Hotwire™ DSLAM for 8000 MCC and 8540/8546 DSL Cards Firmware Update Description, Release 2.03.15

Document Number 8000-A2-GK52-00

October 1998

This document contains information that been added in the Hotwire™ Models 8540 and 8546 DSLAM (Digital Subscriber Line Access Multiplexer) system as a result of Firmware Release 2.03.15. This document is to be used in conjunction with the following documentation:

DSL Link Performance Summary

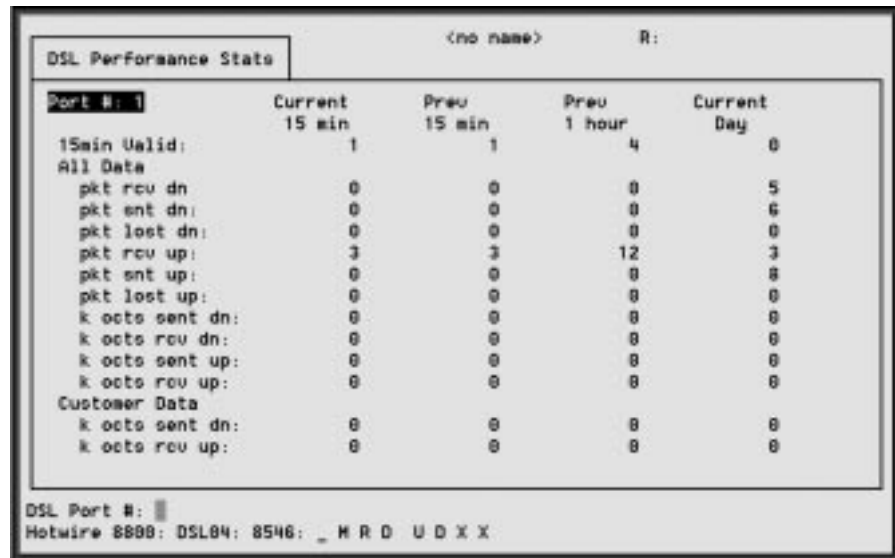
Four fields have been added to this screen:

- **link dn count** – Displays the number of times the DSL link has failed.
- **elp link up** – Displays the count, in seconds, of the interval between when the DSL link has gone down and come back up.
- **elp time** – Displays the count, in seconds, of total elapsed time the DSL link has been up.
- **pct link up** – Displays the percentage of time the DSL link has been up.

DSL Performance Stats

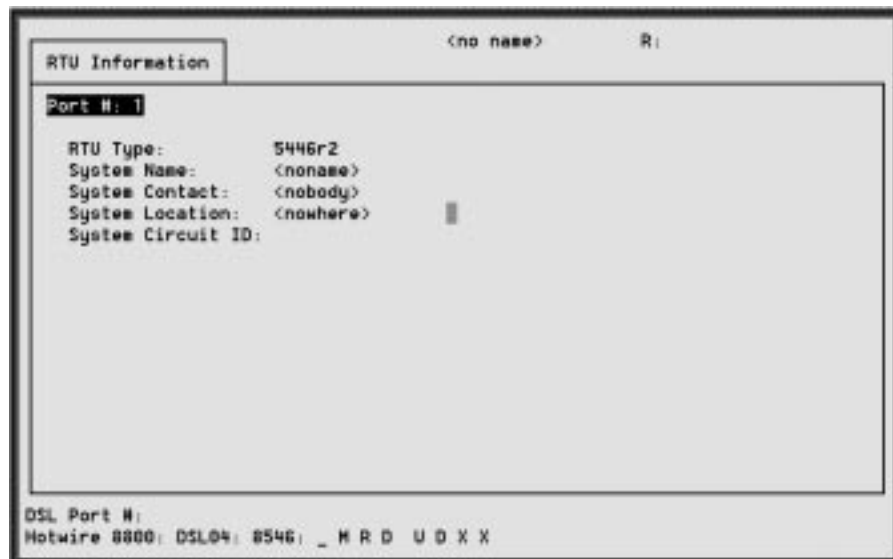
Two fields have been added to this screen under **Customer Data**:

- **k octs sent dn** – Displays the number of octets (in thousands) of customer data sent by the DSL card to the endpoint.
- **k octs rcv up** – Displays the number of octets (in thousands) of customer data received by the DSL card from the endpoint.
